**NOTICE OF  
ARCHITECTURAL REVIEW BOARD DECISION**

**\*\* APPROVAL WITH CONDITIONS\*\***

Case #:	AR 19-0008
Project:	Tualatin Industrial Park
Location:	11040 SW Tualatin-Sherwood Rd, Tualatin, OR. Tax Lots: 2S122D000600, 2S127AA00500, 2S122DD00700
Applicant:	T. Chavez, Phelan Development
Owner:	Myslony Development, LLC

Figure 2: Site Plan (overview)

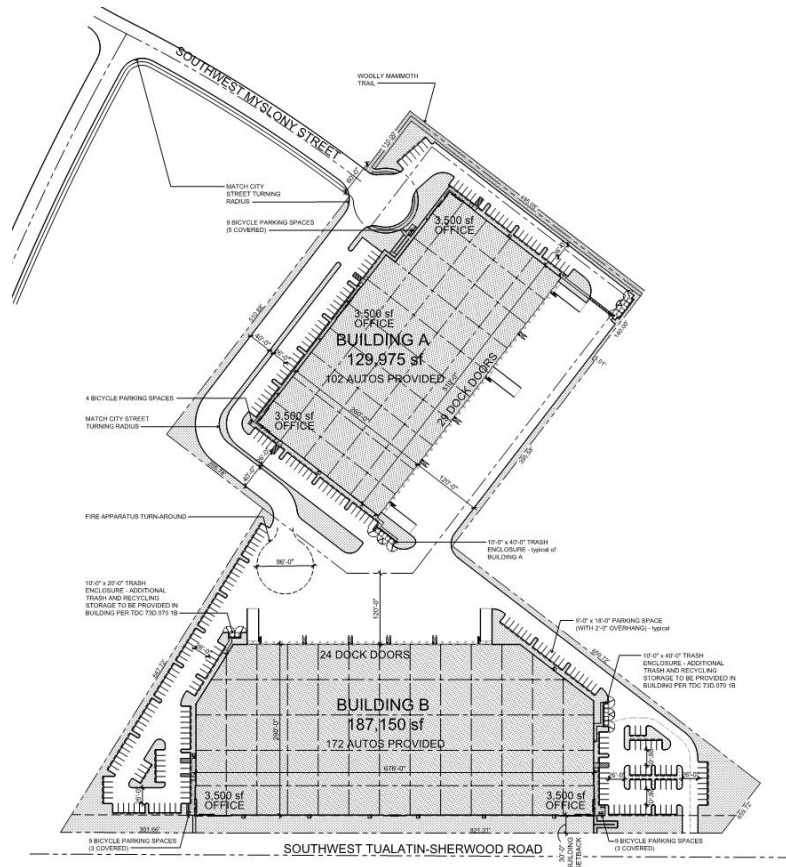
*The front setback at SW Myslony Street is less than the minimum 30 feet required by the standards of this section. All other setbacks are proposed to be met. With recommended Condition of Approval A3 requiring modifications to meet the minimum front setback, these development standards will be met.*

*The design of the parking lot will not require movement on the public street. Drive aisles with parking are at least 26 feet wide as proposed. A drive aisle from SW Myslony Street to Building B is proposed at 40 feet wide. At the north end of the site at Building A, the drive aisle width may need to be modified in order to accommodate the full area of the required easement for the Ice Age Tonquin Trail. With recommended Condition of Approval A3, these standards will be met.*

Since 264 parking spaces are required, 11 are required to be carpool/vanpool spaces. No carpool/vanpool spaces are designated on the plans. With Condition of Approval A3, this standard is met.

- A3. The applicant must submit a Final Site Plan Set (in PDF format) to the Planning Division that is in substantial conformance to the submitted site plans and includes:
  - a. Building setbacks at least 30 feet from front property line at SW Myslony Street.

- b. A site configuration on the North side of Building A that will meet parking stall length (*TDC Figure 73-1*), drive aisle width (*TDC 73C.020*), and ingress/egress standards (*TDC 73C.130(3)*) without encroaching into the required easement for the Ice Age Tonquin Trail as discussed in the City Engineer's Decision. No development other than landscaping, and pedestrian amenities related to the future trail, are permitted within the easement.

- e. Eleven parking spaces designated as carpool/vanpool parking, consistent with *TDC 73C.100(2)*.
  - f. Deciduous trees planted no more than 30 feet apart on the perimeter of vehicle circulation areas consistent with *TDC 73C.230(3)*. Such trees may be omitted where the perimeter area is also within a Public Utility Easement as required by the City Engineer's Decision, and where there are existing trees at or near the property line.

- g. At least 502 square feet of designated interior waste storage area.
  - h. Landscape plan revisions replacing all instances of *Pistacia Chinensis* (Chinese Pistache) with a non-fruit-bearing deciduous tree, such as Sterling Silver Linden.
